# PLANNING BOARD MEETING

c. Project: Site Plan – Dandy Mini Mart – Convenience (Mini) Mart

This is our response to the comments provided on June 10, 2022, for the above-referenced project. The following is an item-by-item response, numbered in accordance with your original comments.

**PHOTOMETRICS PLAN**  
**C8**

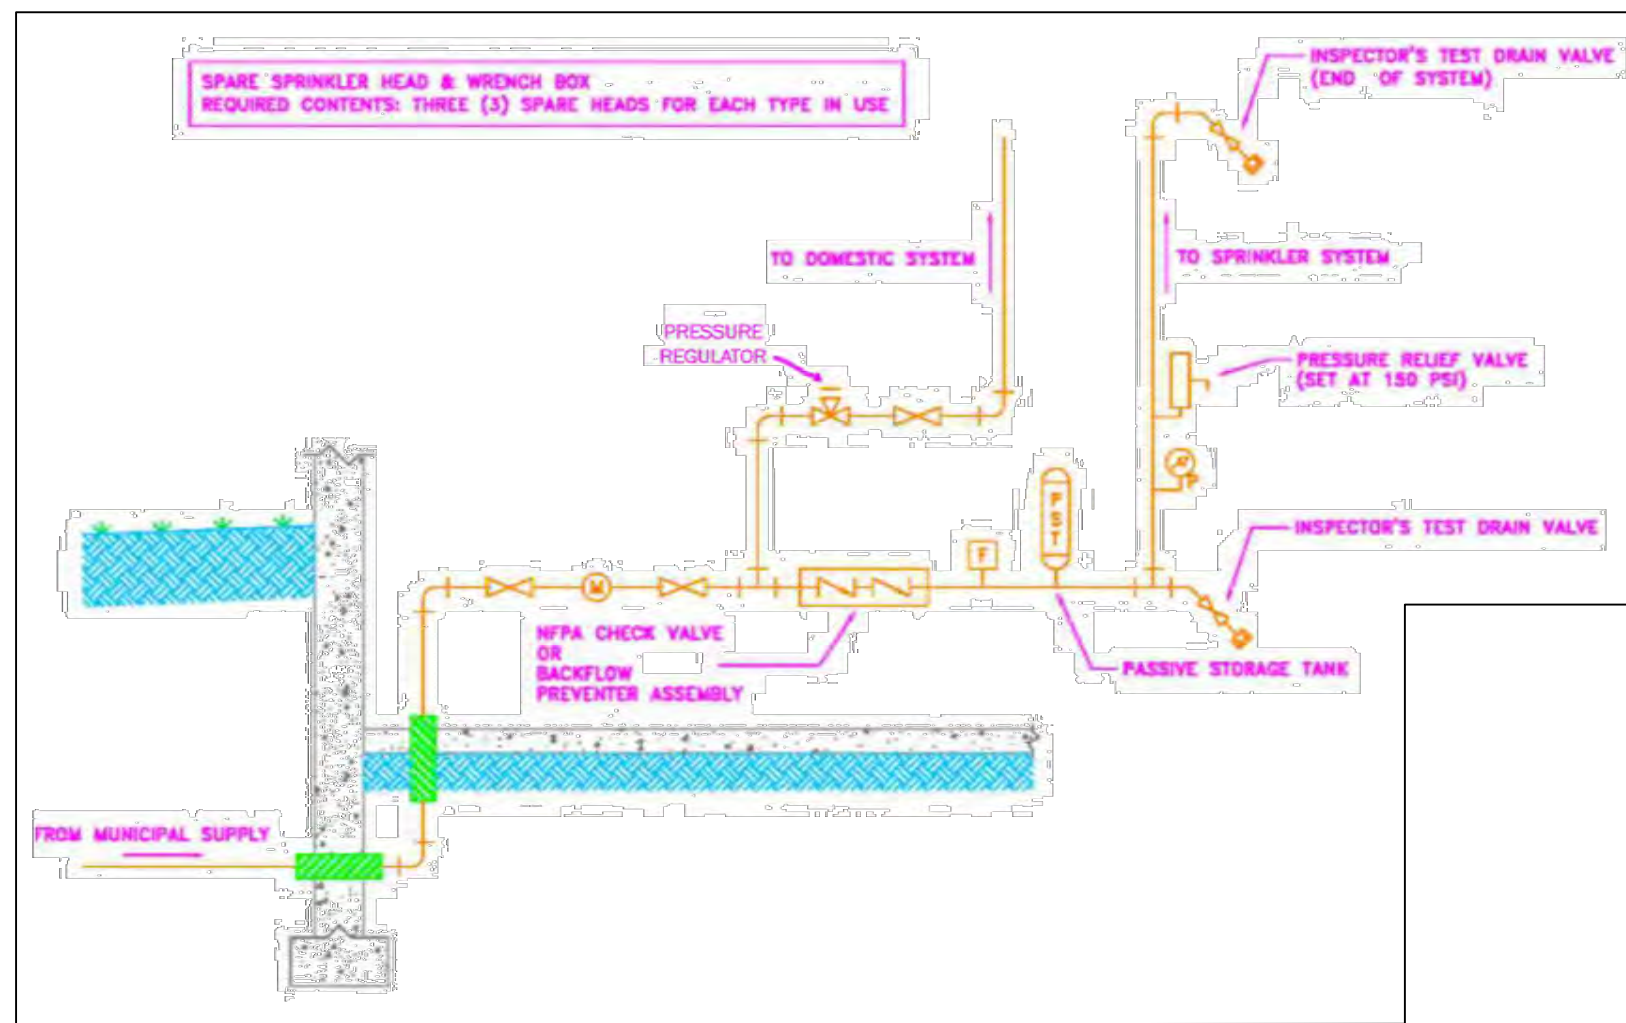
*C6 Please provide a photometric plan. Note that light spillage is not allowed within the NYSDOT ROW.*

**R6 Please see revised Plan Sheet C8 for photometrics plan.**

**WATER CONNECTION DETAIL**  
N.T.S.

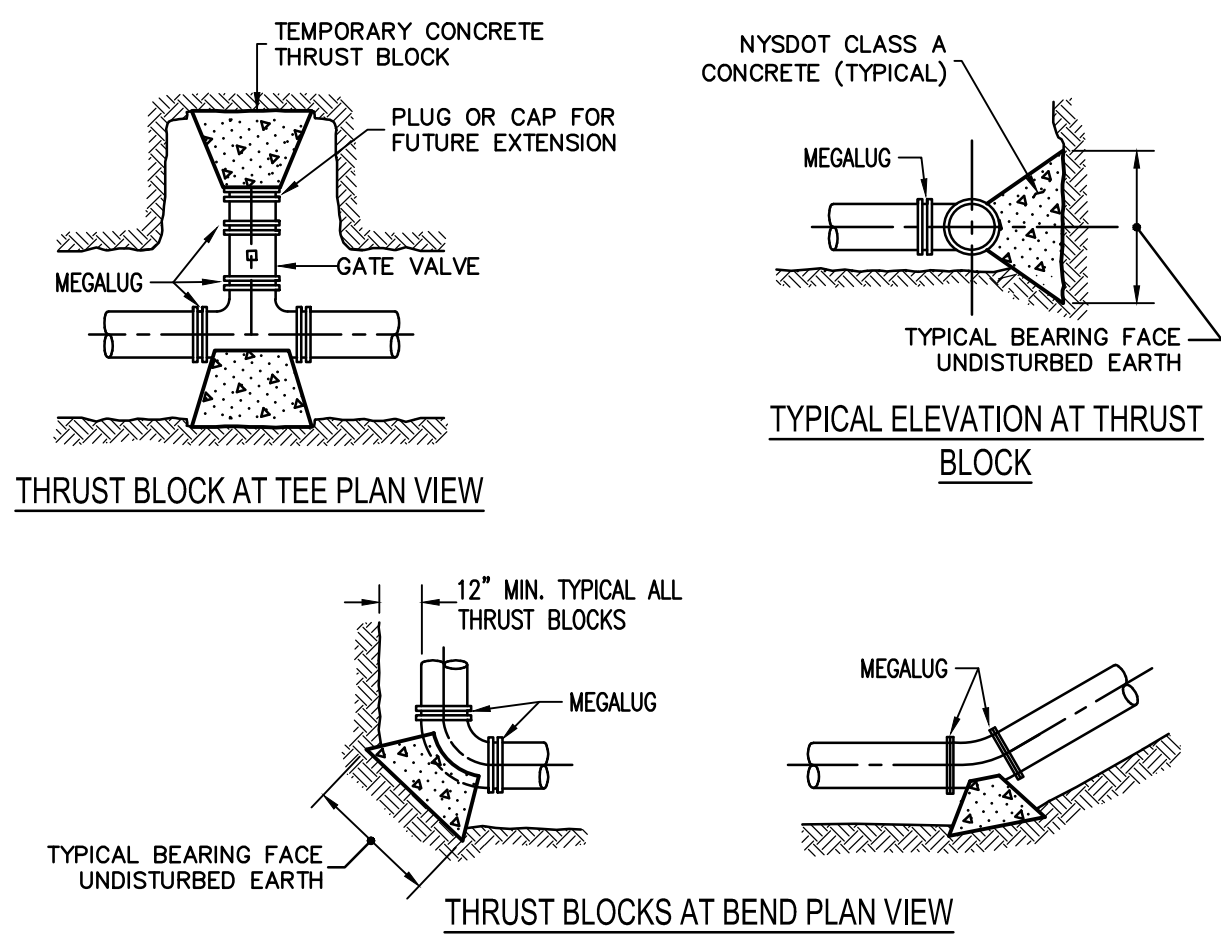
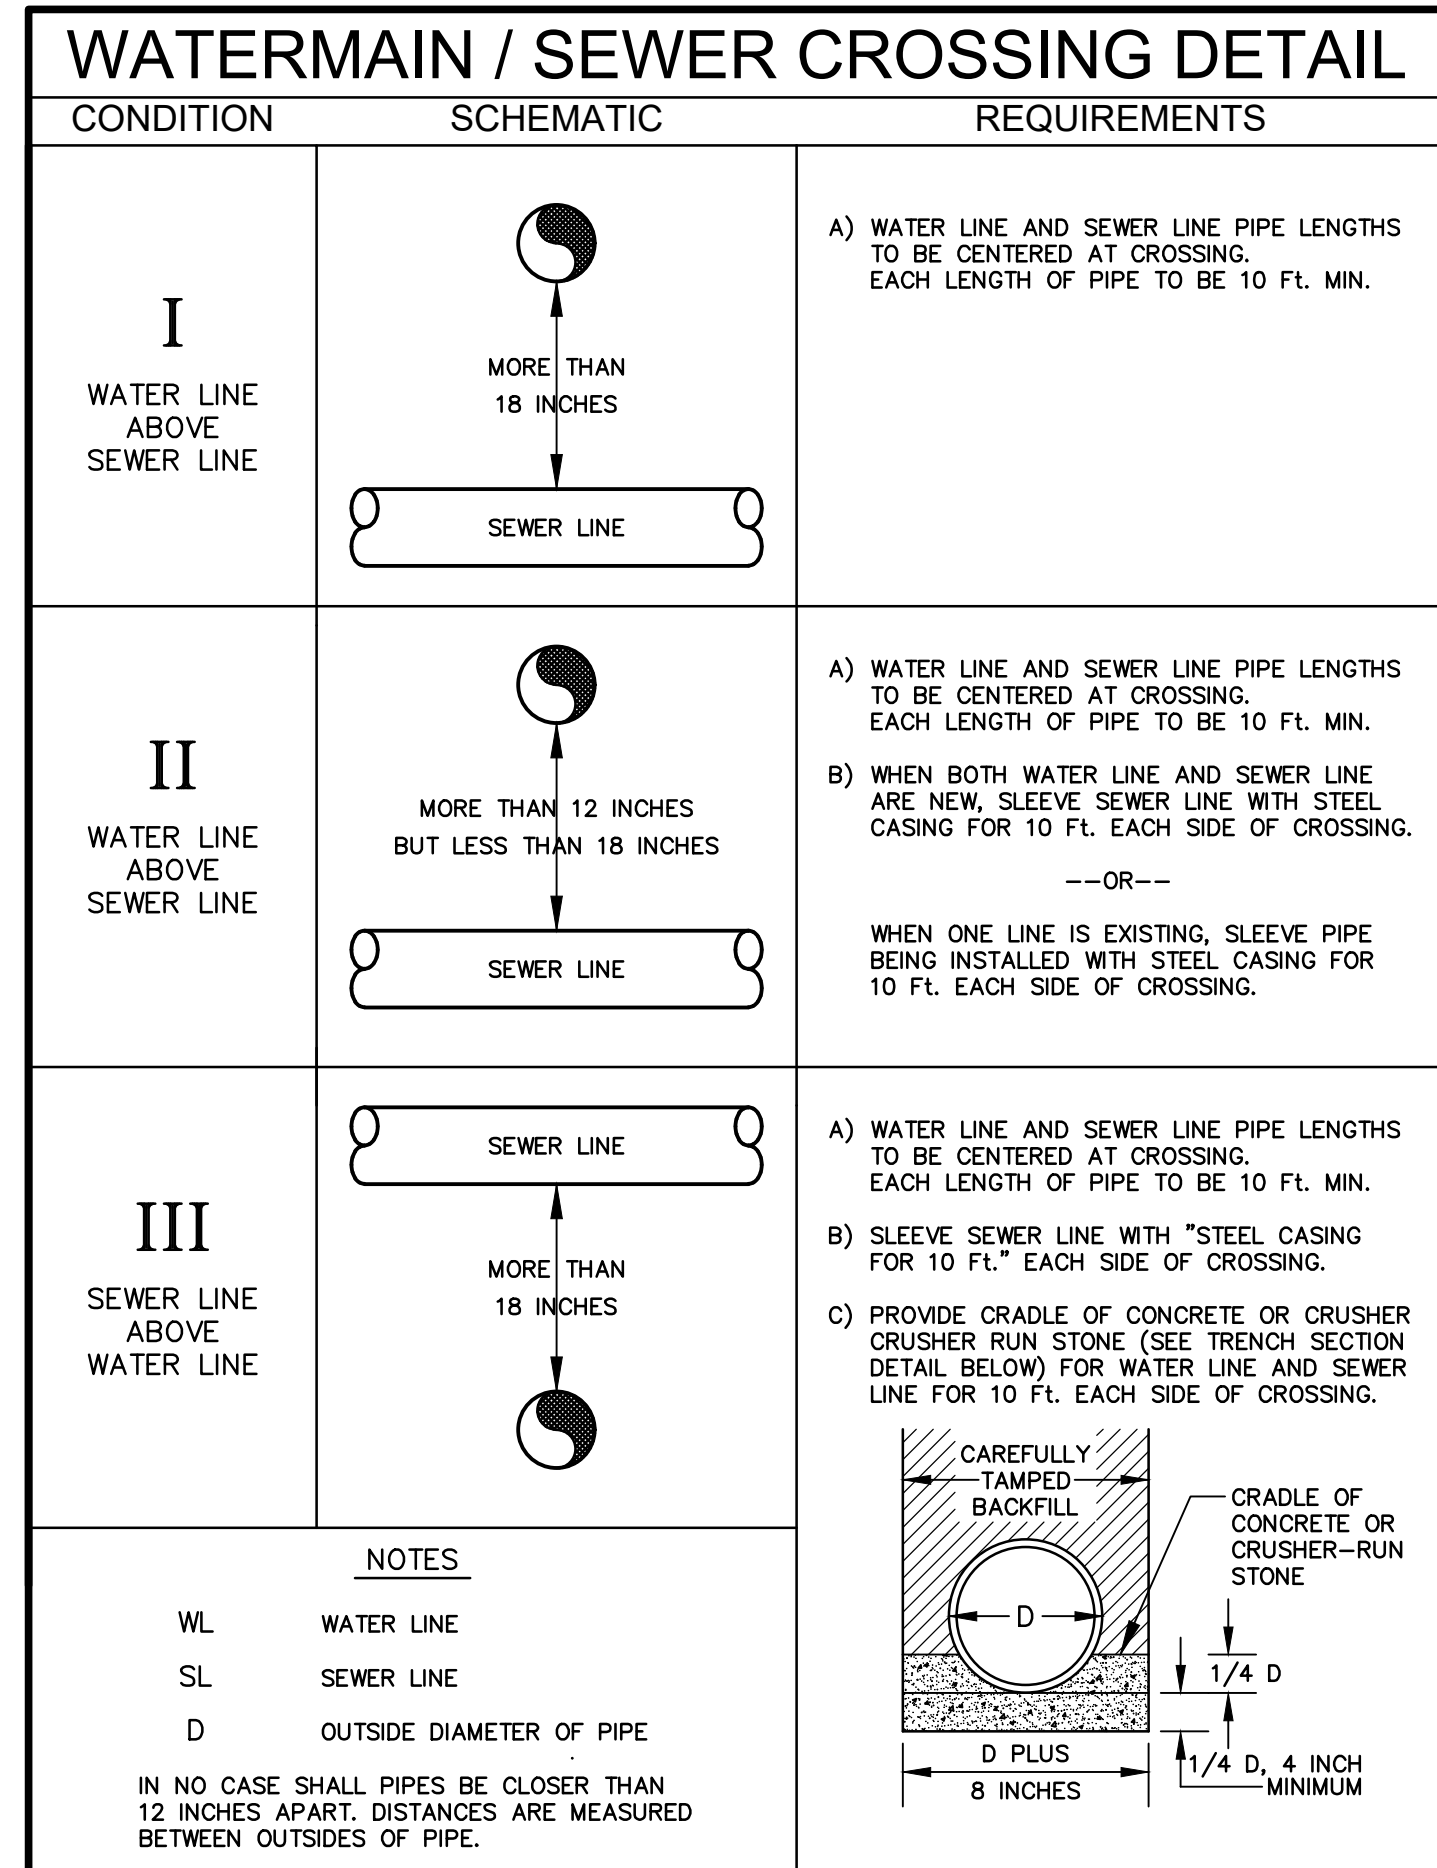
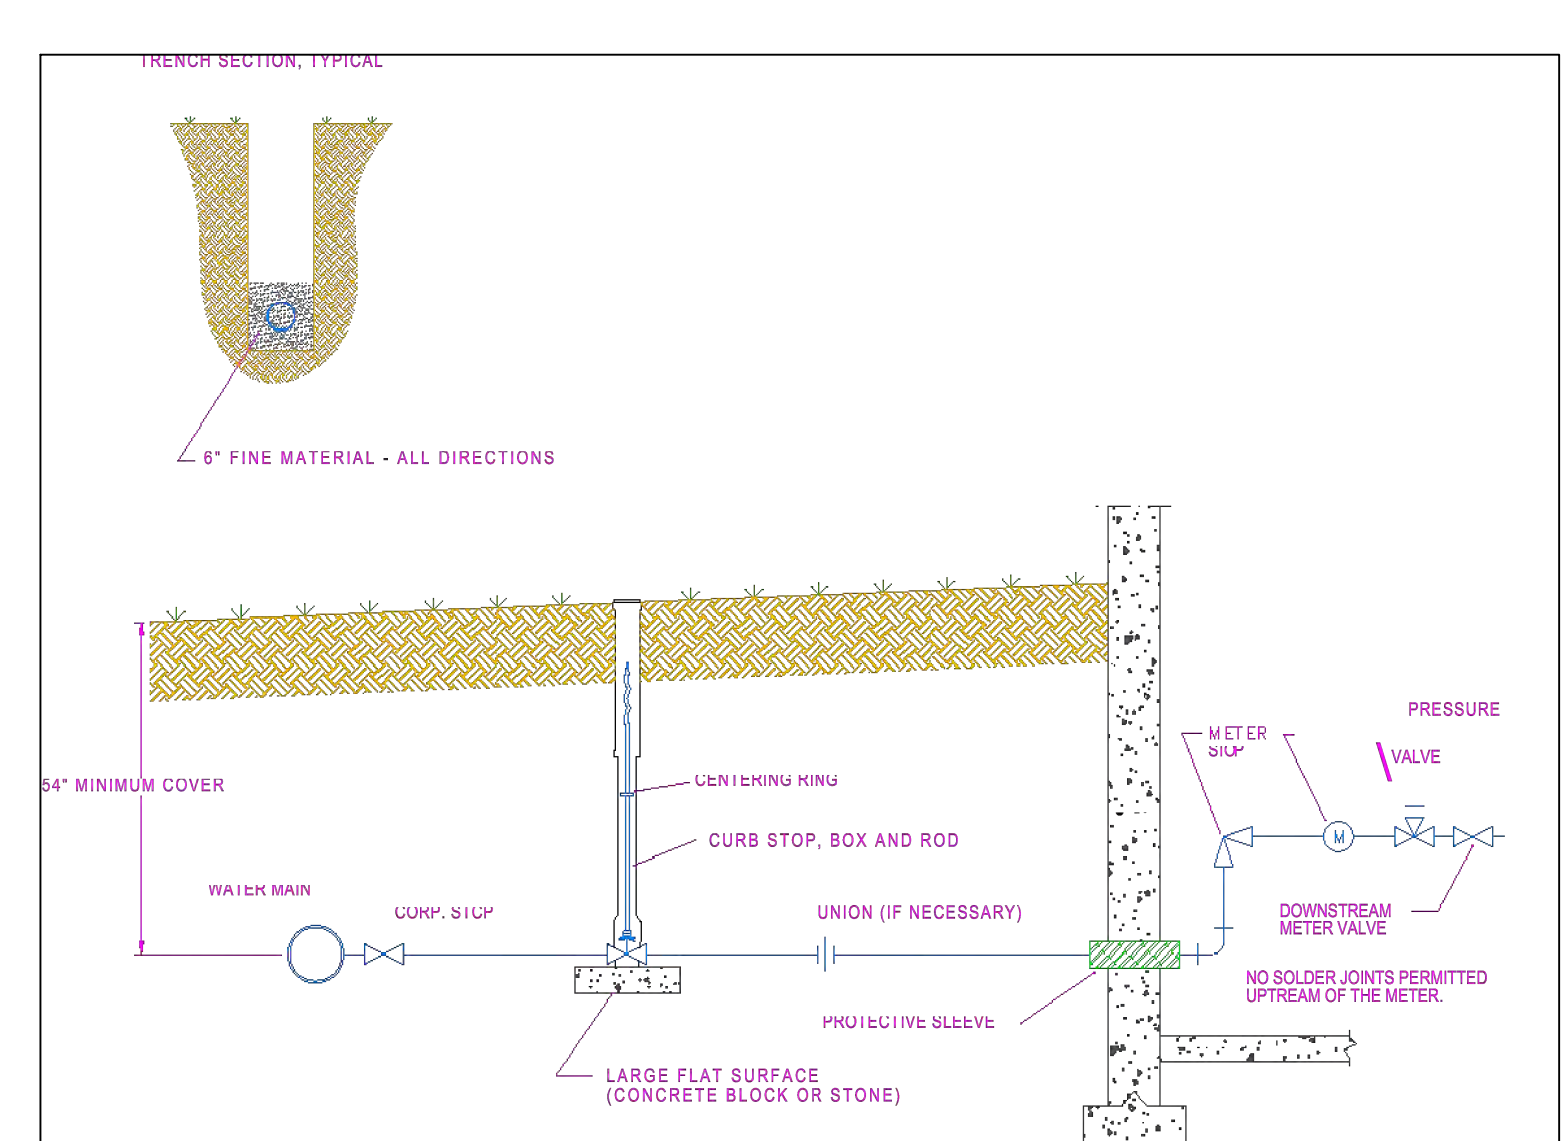
*4. According to the Water Service Detail on Sheet C8, the material of the building's water service is indicated as HDPE. Per Town standards, all water services are required to be copper up to the curb stop. This detail should be modified to reflect copper piping.*

*5. Per Town standards, a Mueller BR-2-S Service Saddle or approved equal is required for a 2" water service. Please modify the Water Service Detail on Sheet C8 to include a service saddle.*

**R4: Please see revised Plan Sheet C5 for updated water line notes.**

**R5: Please see revised Plan Sheet C9 for revised details.**

SHOULDER REPAIR PAVEMENT SECTIONS

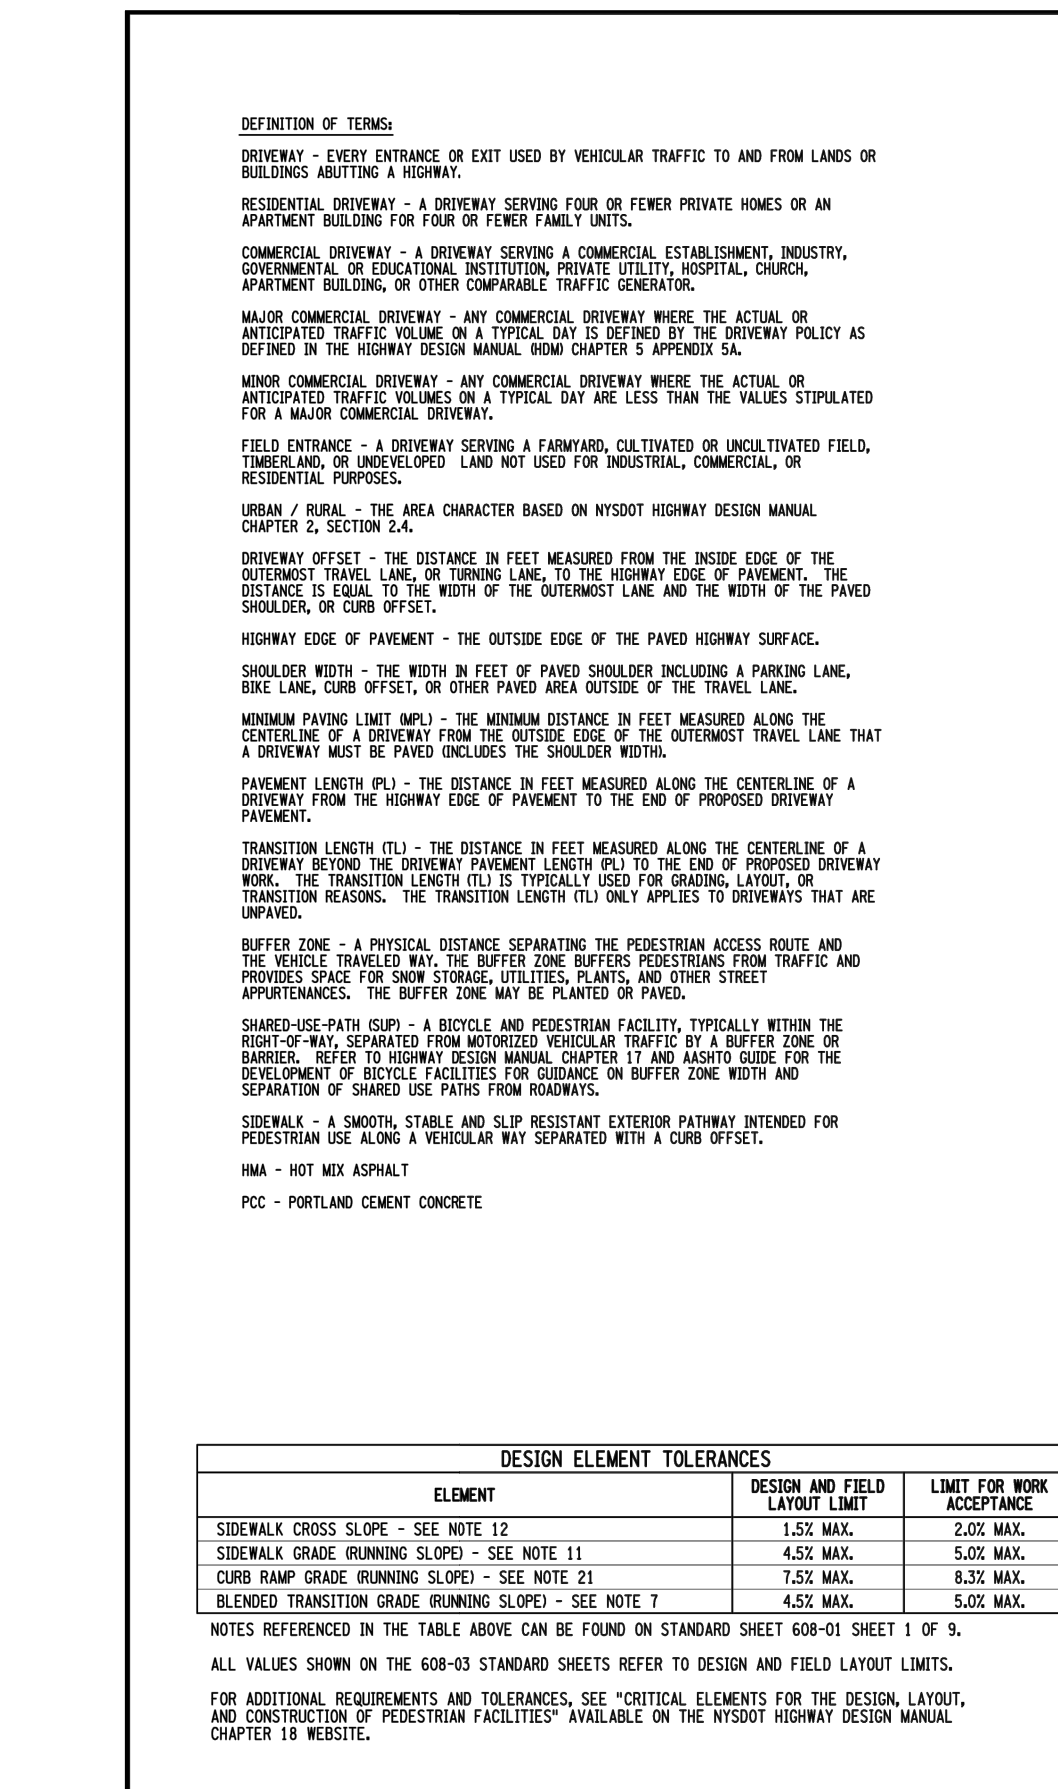
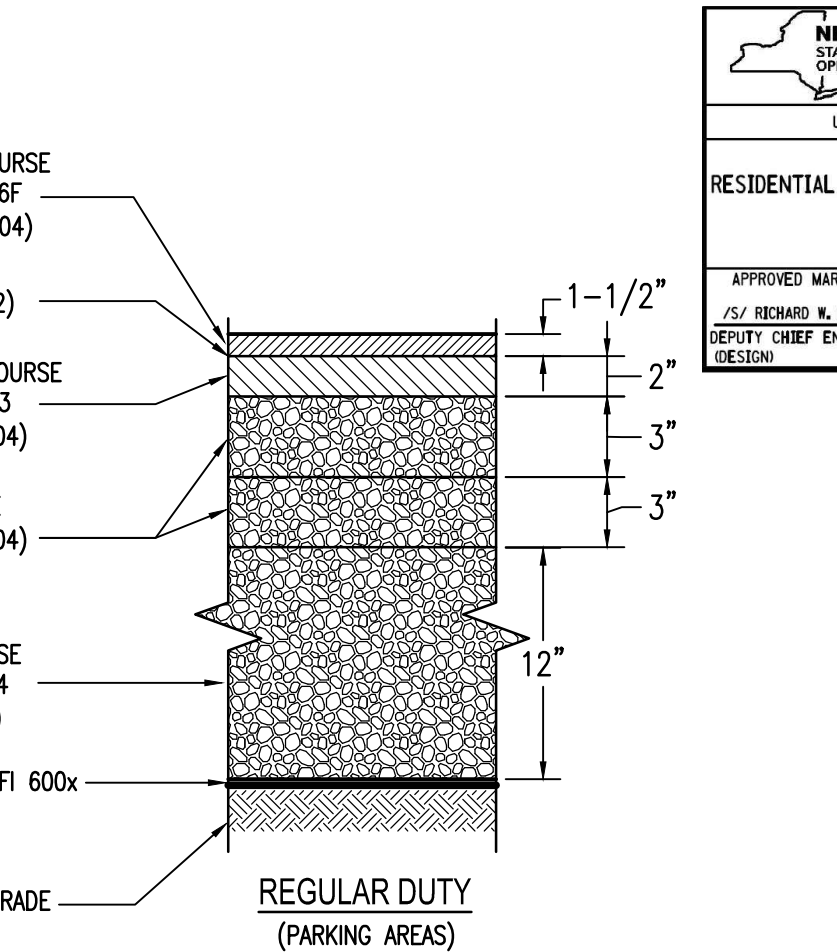
*C7 Heavy duty shoulder recon detailed on sheet C9 is not called out on any of the plan sheets. Please update or add a plan sheet that calls out the shoulder recon per the attached driveway plan 50-10. Please reference the sheet in the detail so it is easier to find.*

**R7 Please see revised Plan Sheet C3 for added shoulder reconstruction note. Also please see revised Plan Sheet C10 for “Shoulder Repair Pavement Sections” detail.**
